AGENDA
CITY OF CREVE COEUR
PLANNING AND ZONING
300 NORTH NEW BALLAS RD
OCTOBER 2, 2023
6:00 PM

**APPLICATIONS TO PLANNING AND ZONING COMMISSION
#23-027 AND #23-028: FOR A REZONING FROM “RO” RESEARCH
OFFICE DISTRICT TO THE OLIA VILLAGE “PMD” PLANNED MIXED-
USE DEVELOPMENT DISTRICT WITH A SITE CONCEPT PLAN, PHASE
ONE SITE DEVELOPMENT PLAN AND ASSOCIATED PRELIMINARY PLAT
FOR THE 96 ACRE PROPERTY AT 10300 OLIVE BOULEVARD**

REVISED PLANS SUBMITTED IN RESPONSE TO SEPTEMBER 18TH P&Z REVIEW

Figure 4: Sheets L-141 and L-144 showing details of proposed additional landscaping in the residential buffer yard.

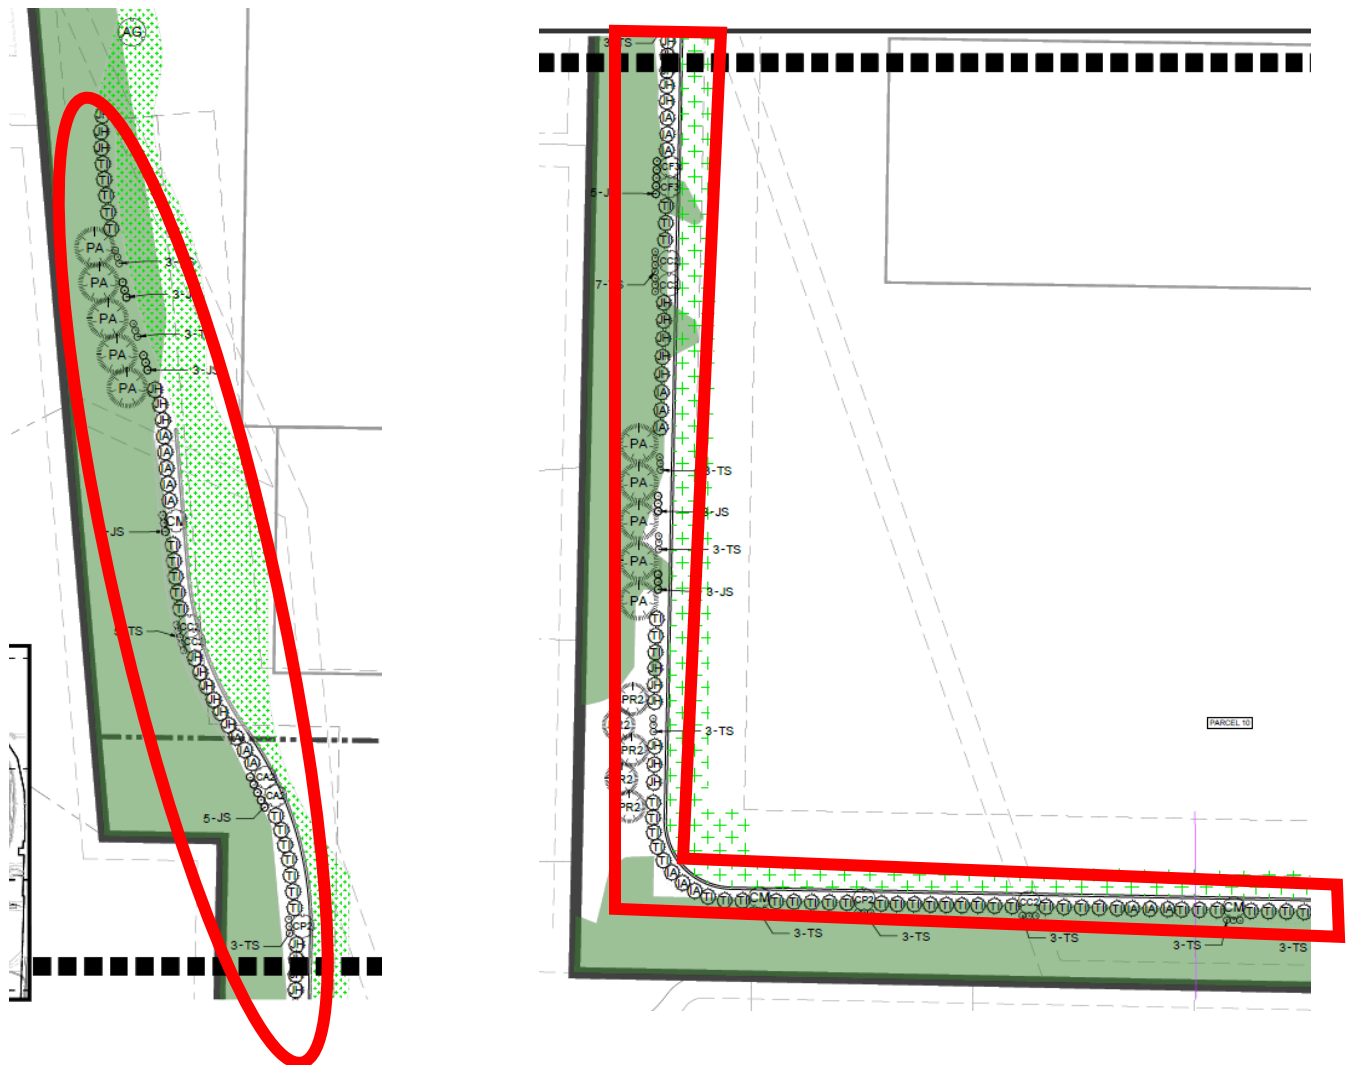
Phase One of the development includes site clearing (including tree removal), mass grading, site utilities, retaining wall and roadway construction for the development. This site work phase will prepare the site for future build-out that will occur in phases. All building construction will take place in Phases 2-5. The amendments to the Site Concept Plan are also reflected in the Site Development Plan. The Site Development Plan also includes a more detailed concept landscaping plan for Phase One, as asked for by Staff. The revised landscaping plan includes a plant schedule of all proposed plantings in this phase including type and size at time of planting. There is a significant amount of landscaping proposed to be included within the 40-foot residential buffer yard in front of the retaining wall. The landscaping includes a continuous, dense row of evergreen trees mixed with the remaining existing trees to help block the visibility from the residential properties to the proposed development in order to help reduce light or noise pollution and provide screening for the wall itself for the portion that is visible to the adjacent properties. Staff recommends that the final landscaping plan should be amended to show the evergreens to be 8 feet tall at time of planting and all other trees to be 2.5 caliber inches at time of planting within this buffer area. Further, a condition could be added to require additional plantings, if necessary, based on “as-built” conditions in association with the site improvement permit final landscaping inspection. This condition has been provided in the draft ordinance to ensure sufficient screening is in place.

Figure 1: Sheet C-101 of Site Concept Plan showing retaining wall location outside residential buffer yard.

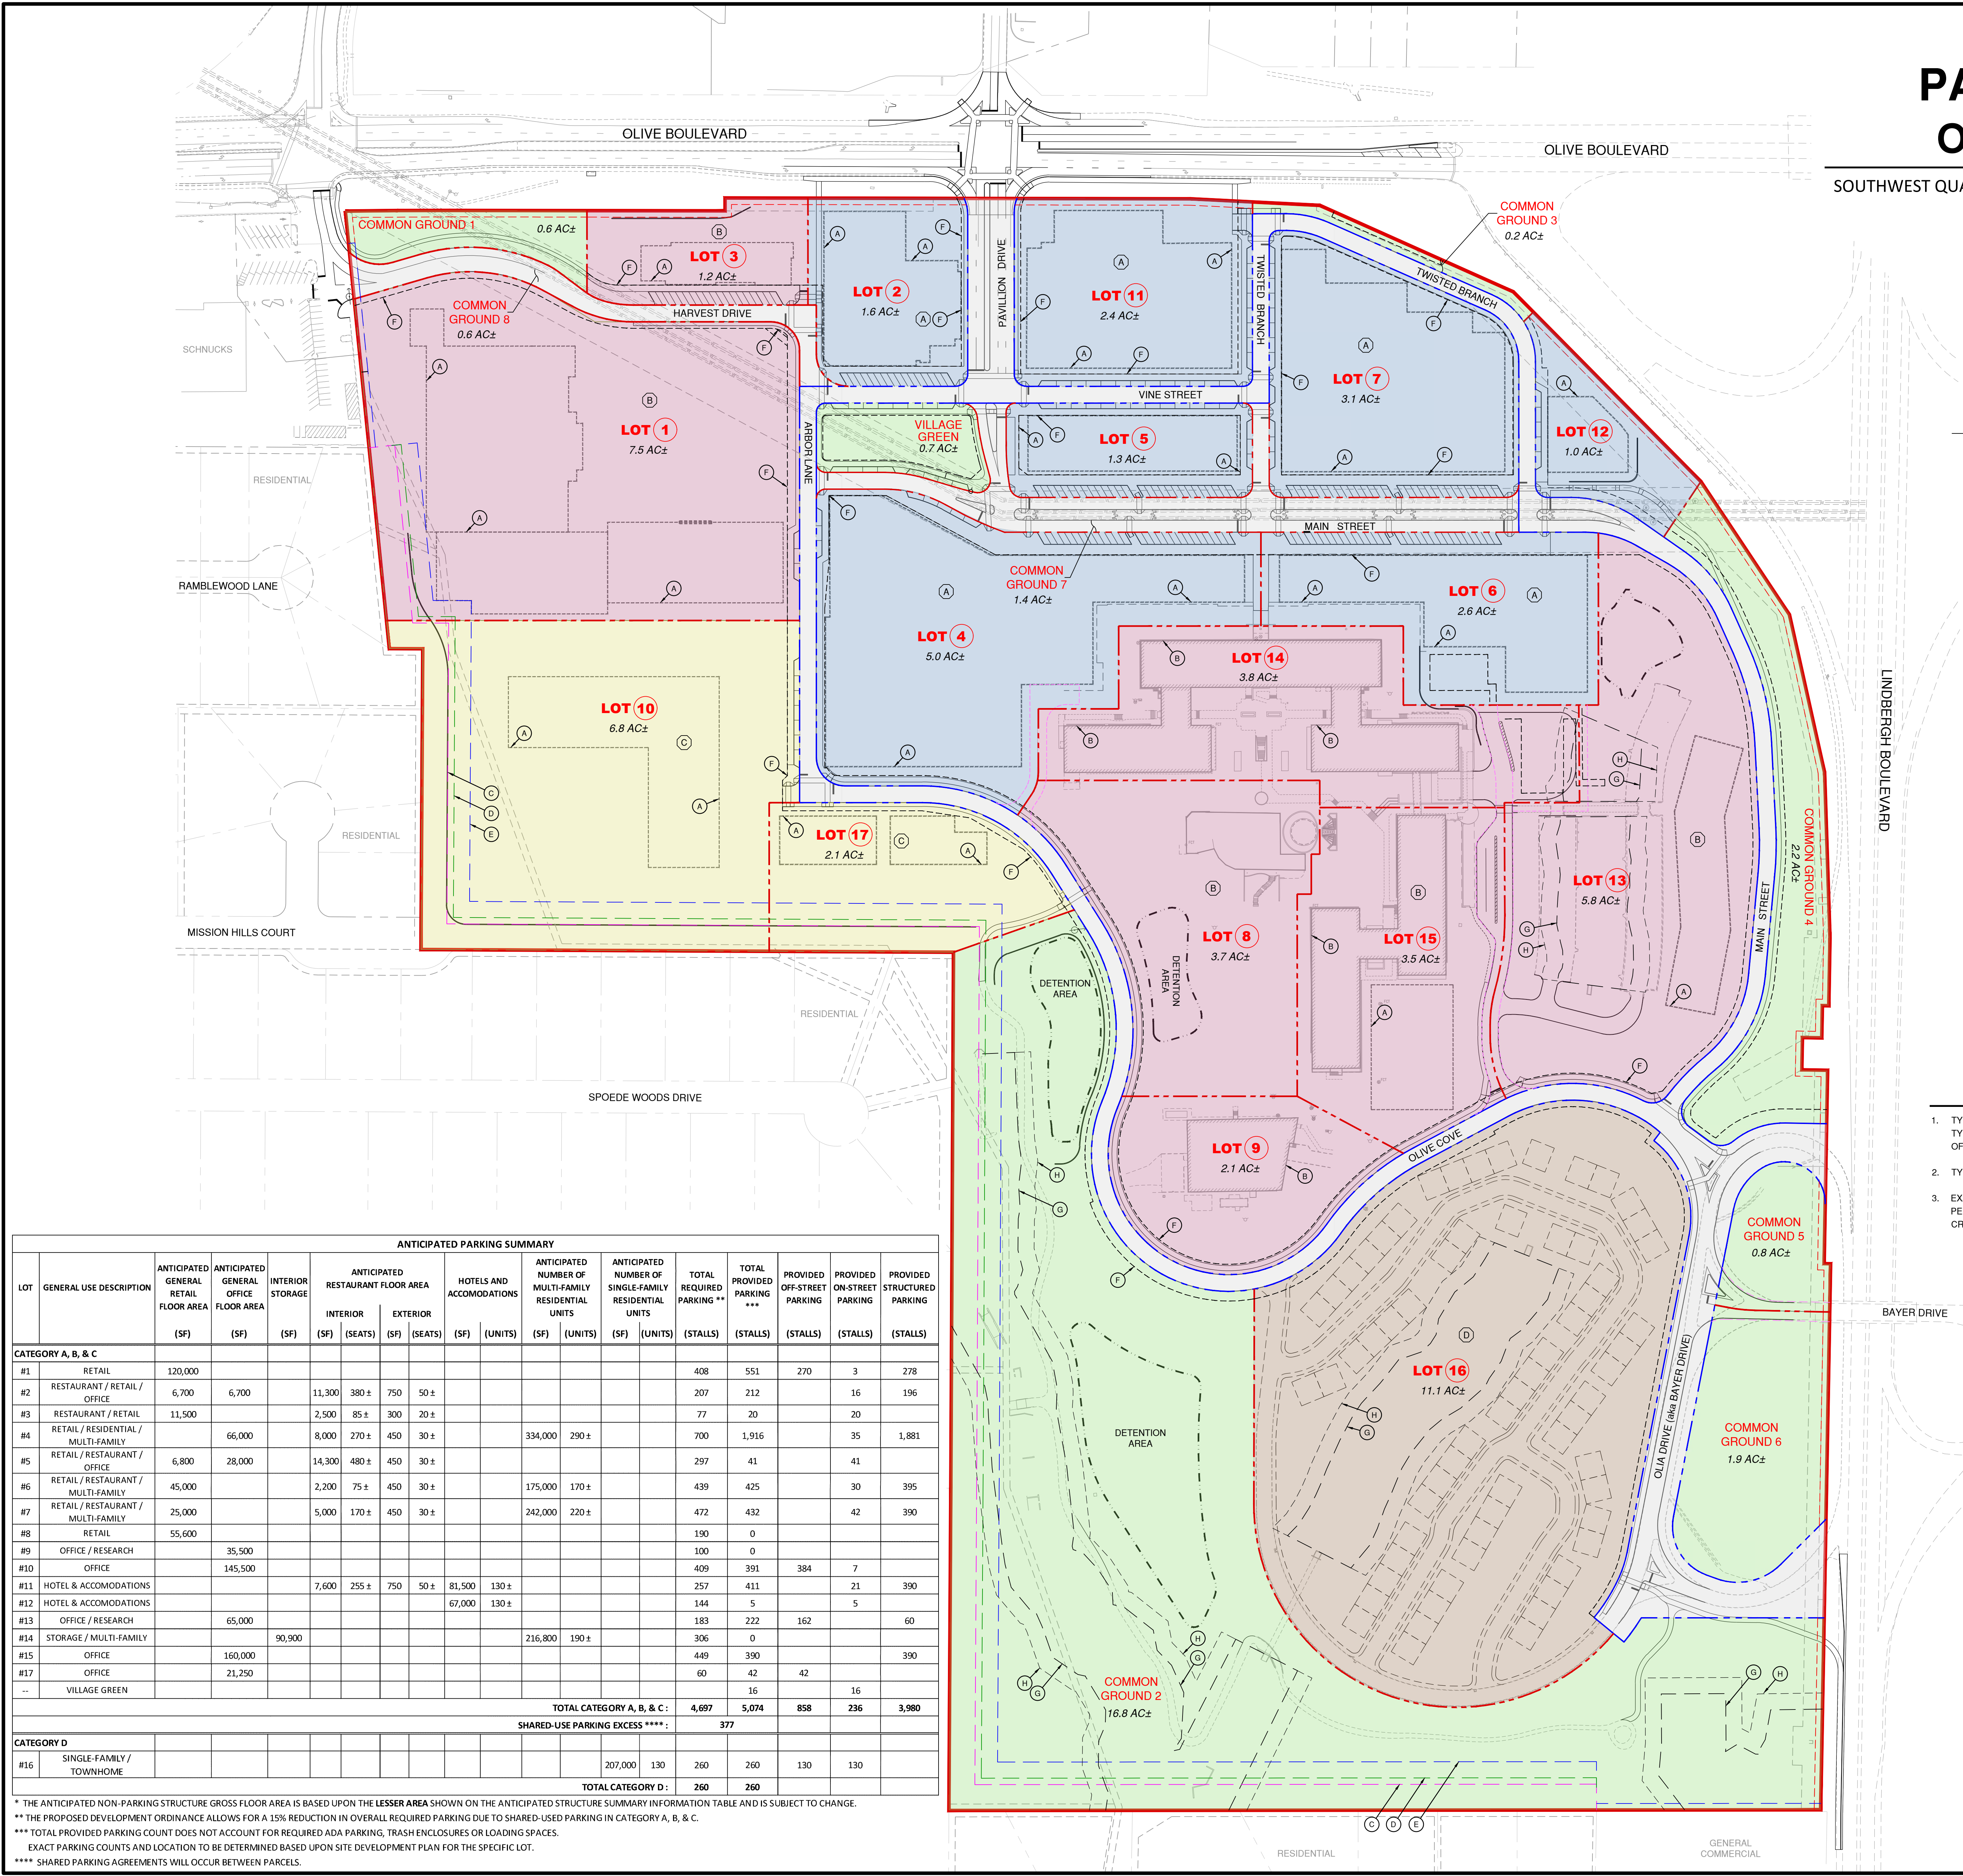
Additional information about the retaining wall has also been provided and reflected on the plans on Sheet C-101 of the Site Concept Plan. The retaining wall will have a maximum height of 20 feet on the portion that faces inward toward the site. Due to the existing grade changes on site, the retaining wall height will vary but will not exceed 20 feet. When the wall faces the project site, it will be up to 20 feet tall and when the wall faces the residential lots, it will be up to 14 feet in height. The proposed material is Redi-Rock LedgeStone which is designed to replicate rough stone and comes in a variety of face molds to give the retaining wall a more natural look with less repetition in patterns. Sheet C-101 has also been updated to include a new architectural bus shelter at the existing bus stop along Olive Boulevard but no additional details have yet been submitted. Attachment B has also been updated to include language about the shelter. The use table has also been updated to include “Office/Research” as a general use description for Lots 9 and 13 and “Single Family/Townhome” for Lot 16. The green houses proposed for Lot 17 have been removed.

8. General Uses. The table on Sheet C-101 has been updated to include "Office / Research" general use description for Lots 9 & 13 and "Single-Family / Townhome" for Lot 16. The Architectural Site Plan (A-101) has been updated to remove the greenhouses on Lot 17.
